Request for Proposals (RFP)

The supply, delivery and commissioning of Parallel File System Storage Hardware, and Software, and Maintenance and Support to the CSIR for a five (5) year period.

RFP No. 3671/04/02/2025

CSIR Response to the first batch of enquiries/clarifications

Figure 1 : New HPC network diagram

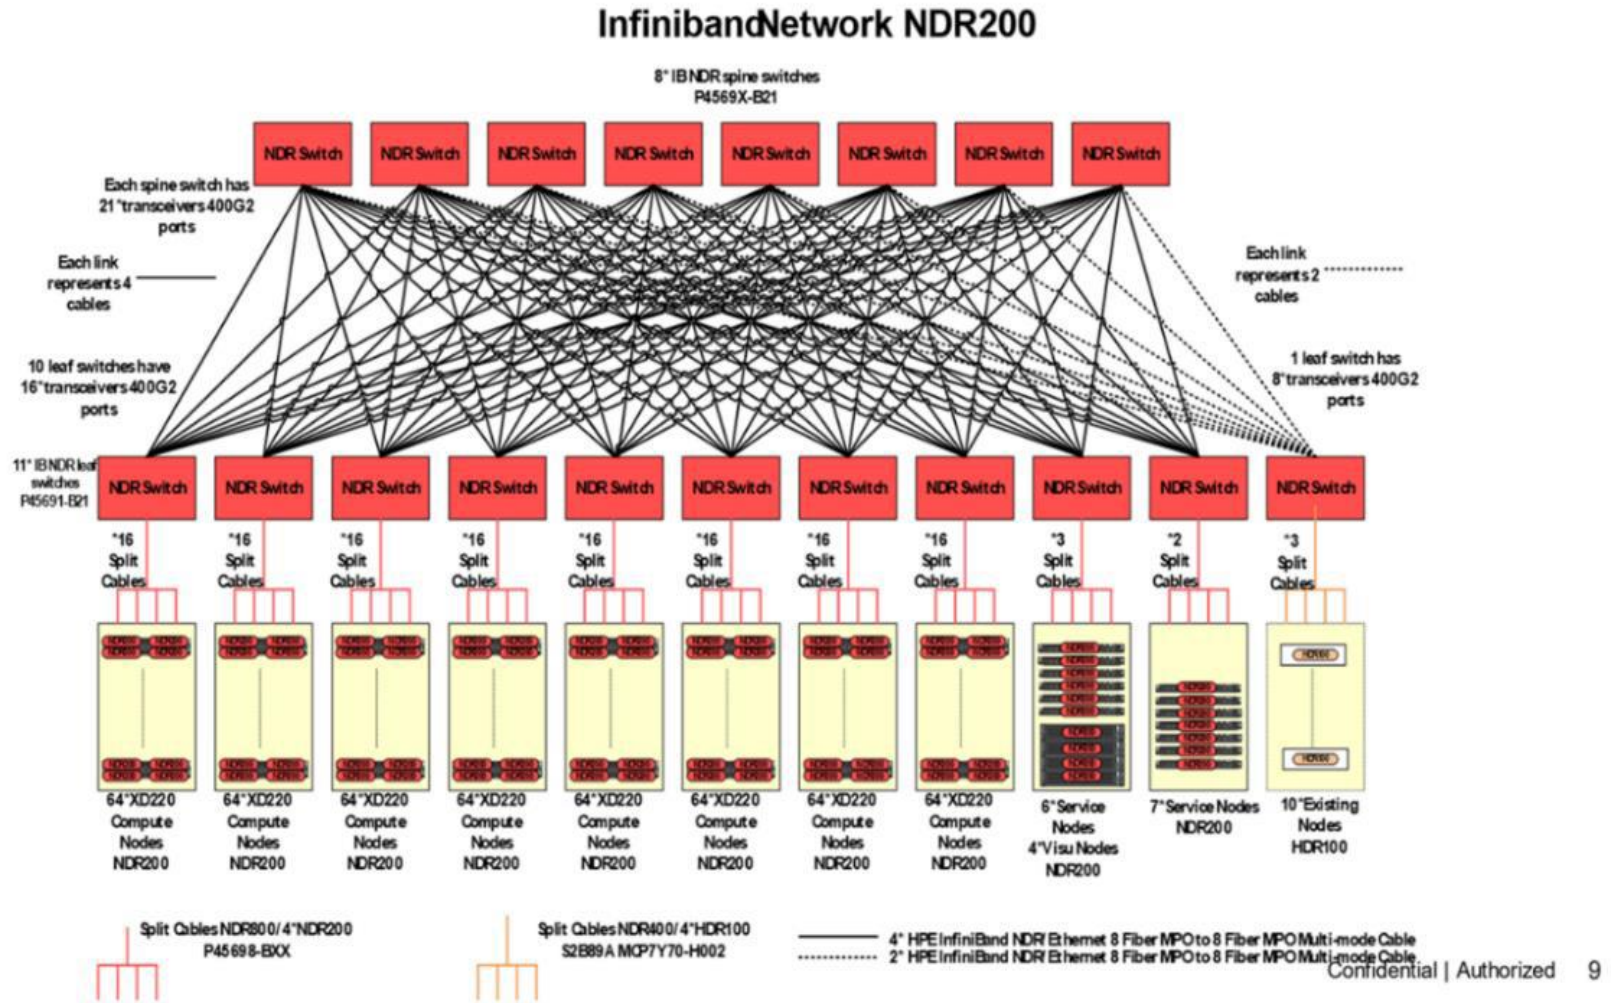
23	Annexure D: If you achieve 75% on the Matrix overall but 0% on one of the criteria will the respondent still be eliminated?	Yes, the bidder must achieve a minimum of 50% on each individual criterion and a minimum threshold of 50% on 100 points overall to be considered further.
24	Annexure D: Figure 1 & 2 - Diagrams – Please can the Network Diagram be provided as separate files such as Visio as the resolution in the RFP is poor?	Please see Figures 1& 2 on pages 8 and 9 of this document.
25	Annexure D: How many Engineer CVs are required?	Minimum of 1 Engineer's CV
26	Annexure D: Must the mandatory documentation be filled out in black ink or can they be filled out electronically? (For instance Annexure B)	Preferable electronic
